Proposal for amendments to GRRF-82-12-Rev.3

The modifications to the GRRF-82-12-Rev.3 are marked in strikethrough for deleted characters and underline for new characters with blue.

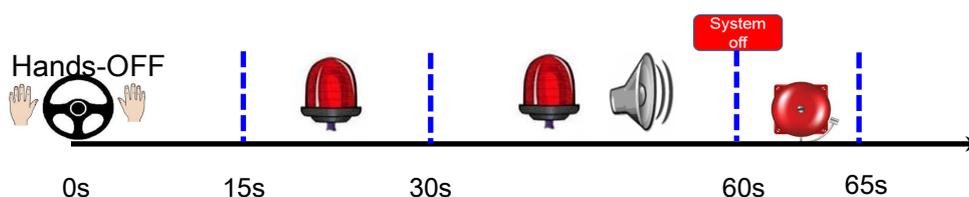
(Justification 1) Korea can agree a French proposal (ACSF-09-03) for test speeds. But, I propose to adopt the way to select a test speed like 5.2.5. of UN Regulation 39 and we may change the contents of the table if necessary. Additionally, to check the mid-speed of system operating range is also likely to be needed.

<u>V_{smax} of the vehicle specified by the vehicle manufacturer (km/h)</u>	<u>Test speed (V_{test})(km/h)</u>
<u>$V_{smax} \leq 60$</u>	<u>$V_{smin}+10, V_{smax}-10$</u>
<u>$60 < V_{smax} \leq 100$</u>	<u>$V_{smin}+10, 40\text{km/h}$ and $V_{smax}-10$</u>
<u>$100 < V_{smax} \leq 130$</u>	<u>$V_{smin}+10, 60\text{km/h}$ and $V_{smax}-10$</u>
<u>$130 < V_{smax}$</u>	<u>$V_{smin}+10, 80\text{km/h}$ and 120 km/h</u>
